Interactive comment on “Using multi-source satellite data for lake level modelling in ungauged basins: a case study for Lake Turkana, East Africa” by N. M. Velpuri et al.

We thank Dr. Garcin for his interest in our paper. We address his comments below.

Fig. 2. Figure showing revised Turkana basin boundary and river networks delineated using SRTM elevation data

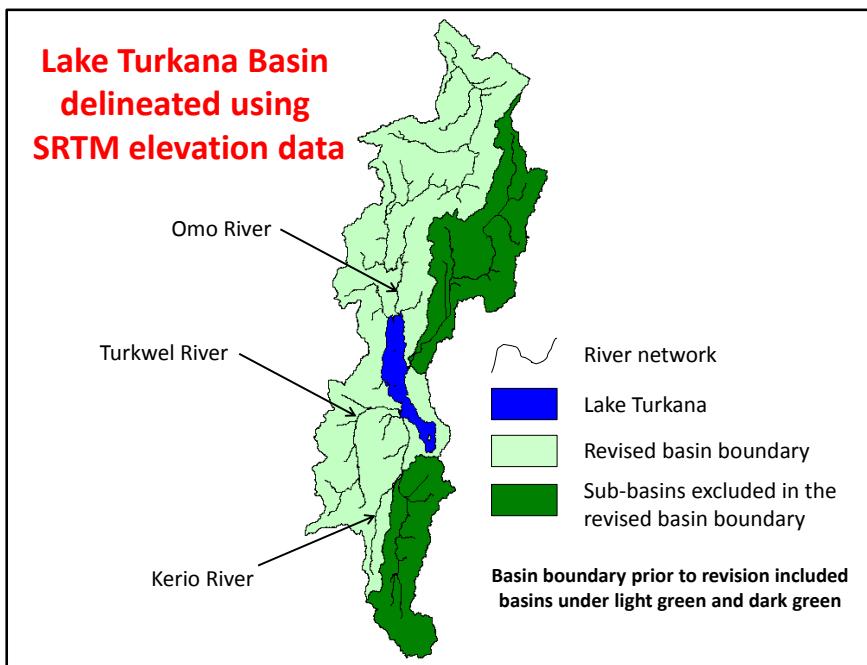
However, as pointed by Dr. Garcin, a close observation of the rivers delineated from SRTM elevation data showed a river network connecting Lake Turkana with smaller rift valley lakes in Ethiopia such as Lake Chew Bahir, Lake Chamo, and Lake Abaya. Nevertheless, since these lakes are not hydrologically connected to Lake Turkana (Nyamweru, 1989), we corrected for the Turkana basin boundary delineated from SRTM by removing the sub-basins corresponding to those lakes. Furthermore, we removed some spurious streams and rivers flowing into Lake Turkana via Kerio River in the south of the basin. Resulting Turkana basin thus obtained was found to have an area of 145,500 sq. km and very closely matches to the basin boundary depicted in the references provided by Dr. Garcin. See figure shown below.

We used this revised basin boundary to re-run the model and found that results obtained after re-running the model are not very different from the one published now. However by using correct basin boundary (with reduced runoff into the lake), we found that the overall accuracy of the modelled lake levels showed slight improvement. The mean bias was reduced from 0.36 m to 0.19 m and we thank Dr. Garcin for suggesting this correction.

We have updated the manuscript, figures and accuracy table with the new results, which will be reflected in the revised manuscript.
